# RENESAS TECHNICAL UPDATE

Product Category	MPU&MCU		Document No.	TN-H8*-A289A/E	Rev.	1.0
Title	Additional of SCI Usage Notes		Information Category	Technical Notification		
Applicable Product	H8S/2282 Group H8S/2612 series H8S/2628 series H8S/2615 Group	Lot No.  All	Reference Document	H8S/2282 Group hardware manual (Rev.2.00 2004.3 REJ09B0148-0200Z) H8S/2612 series, H8S/2612 F-ZTAT™ hardware manual (Rev.4.0 2003.3 ADE-602-220C) H8S/2628 series hardware manual (Rev.2.00 2004.3 REJ09B0155-0200O) H8S/2615 Group hardware manual (Rev.2.00 2004.3 REJ09B0072-0200O)

The descriptions are dropped in the hardware manuals for the H8S Series is amended as shown below.

**Figure 14.34 Sample Flowchart for Mode Transition during Transmission**

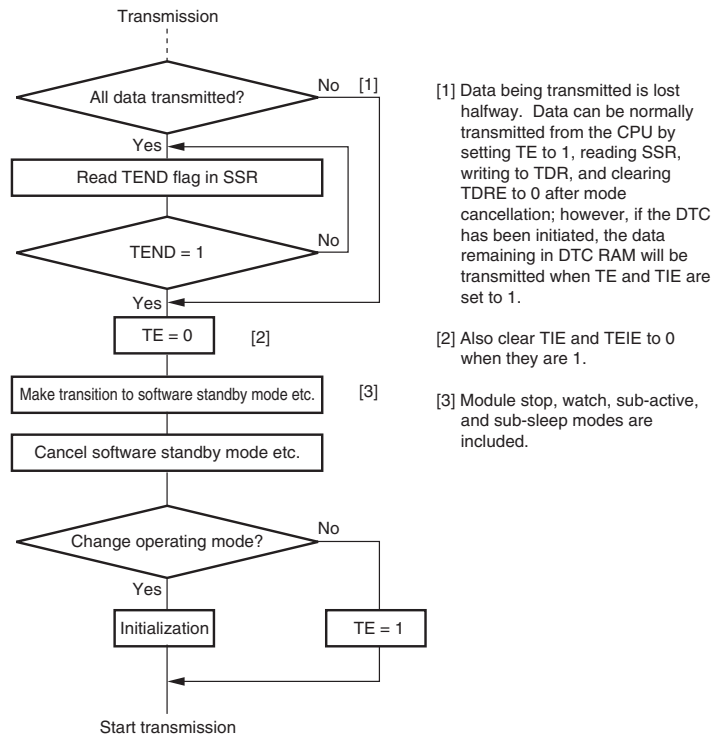
**Transmission:** Before making the transition to module stop, software standby, watch, sub-active, or sub-sleep mode, stop all transmit operations ( $TE = TIE = TEIE = 0$ ). TSR, TDR, and SSR are reset. The states of the output pins during each mode depend on the port settings, and the pins output a high-level signal after mode is cancelled and then the TE is set to 1 again. If the transition is made during data transmission, the data being transmitted will be undefined.

To transmit data in the same transmission mode after mode cancellation, set TE to 1, read SSR, write to TDR, clear TDRE in this order, and then start transmission. To transmit data in a different transmission mode, initialize the SCI first.

Figure 14.34 shows a sample flowchart for mode transition during transmission. Figures 14.35 and 14.36 show the pin states during transmission.

Before making the transition from the transmission mode using DTC transfer to module stop, software standby, watch, sub-active, or sub-sleep mode, stop all transmit operations ( $TE = TIE = TEIE = 0$ ). Setting TE and TIE to 1 after mode

cancellation generates a TXI interrupt request to start transmission using the DTC.

**Figure 14.36 Pin States during Transmission in Clocked Synchronous Mode (Internal Clock)**

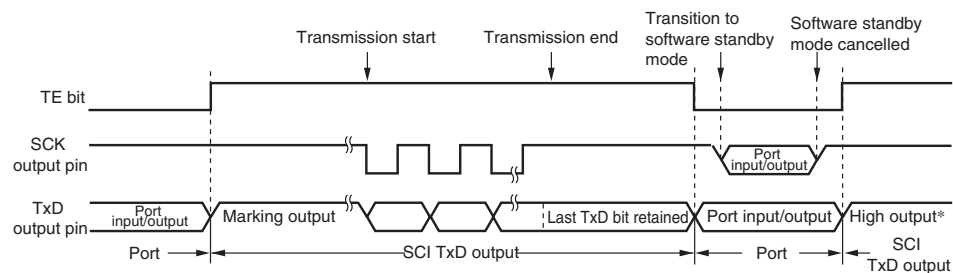
Note: Initialized in software standby mode

**Figure 14.37 Sample Flowchart for Mode Transition during Reception**

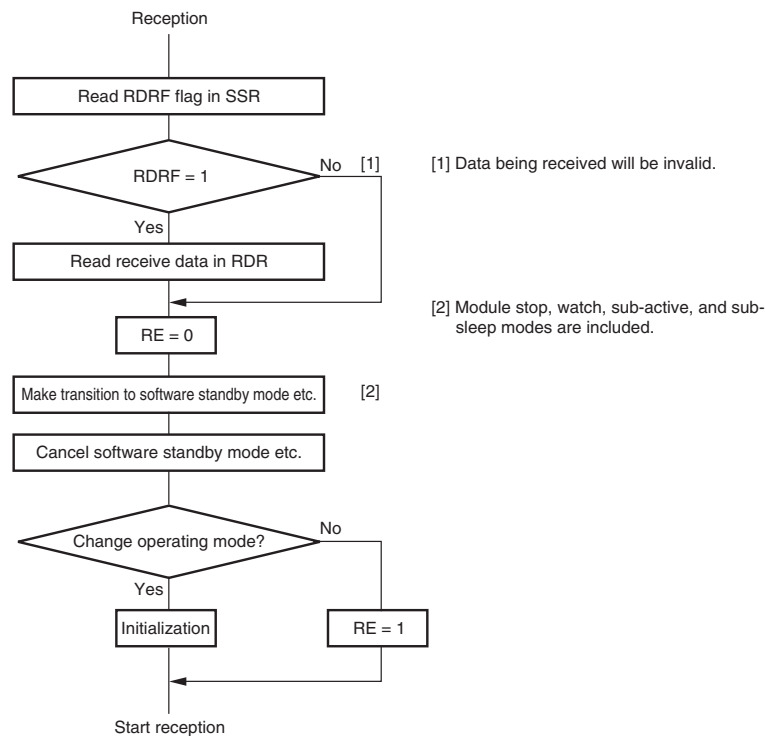
**Reception:** Before making the transition to module stop, software standby, watch, sub-active, or sub-sleep mode, stop reception (RE = 0). RSR, RDR, and SSR are reset. If transition is made during data reception, the data being received will be invalid.

To receive data in the same reception mode after mode cancellation, set RE to 1, and then start reception. To receive data in a different reception mode, initialize the SCI first.

Figure 14.37 shows a sample flowchart for mode transition during reception.

**Figure 14.38 Operation when Switching from SCK Pin to Port Pin**

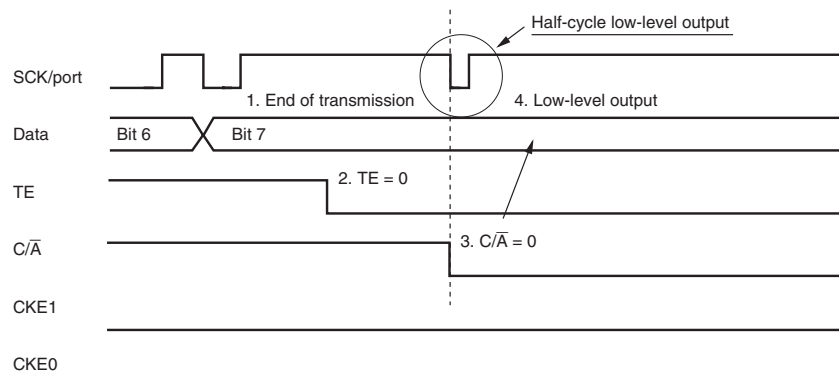
- Problem in Operation: When DDR and DR are set to 1, SCI clock output is used in clocked synchronous mode, and the SCK pin is changed to the port pin while transmission is ended, port output is enabled after low-level output occurs for one half-cycle.

When switching the SCK pin to the port pin by making the following settings while DDR = 1, DR = 1, C/A = 1, CKE1 = 0, CKE0 = 0, and TE = 1, low-level output occurs for one half-cycle.

- End of serial data transmission
- TE bit = 0
- C/A bit = 0 ... switchover to port output
- Occurrence of low-level output (see figure 14.38)

**Figure 14.39 Operation when Switching from SCK Pin to Port Pin  
(Example of Preventing Low-Level Output)**

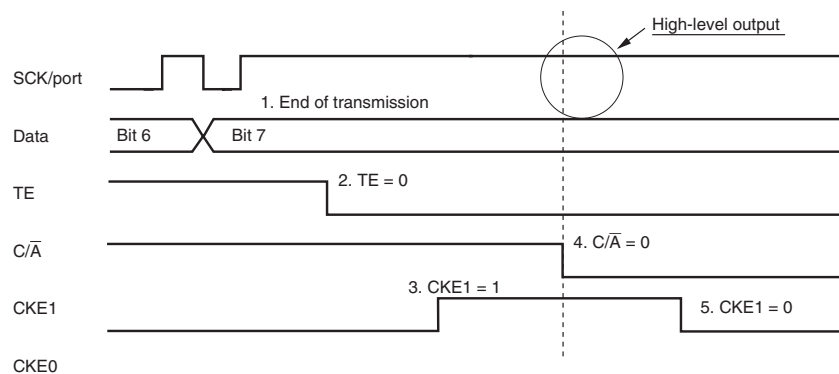
- Usage Note: To prevent low-level output occurred when switching the SCK pin to port pin, follow the procedure described below.

As this sample procedure temporarily places the SCK pin in the input state, the SCK/port pin should be pulled up beforehand with an external circuit.

With DDR = 1, DR = 1, C/A = 1, CKE1 = 0, CKE0 = 0, and TE = 1, make the following settings in the order shown.

1. End of serial data transmission
2. TE bit = 0
3. CKE1 bit = 1
4. C/A bit = 0 ... switchover to port output
5. CKE1 bit = 0
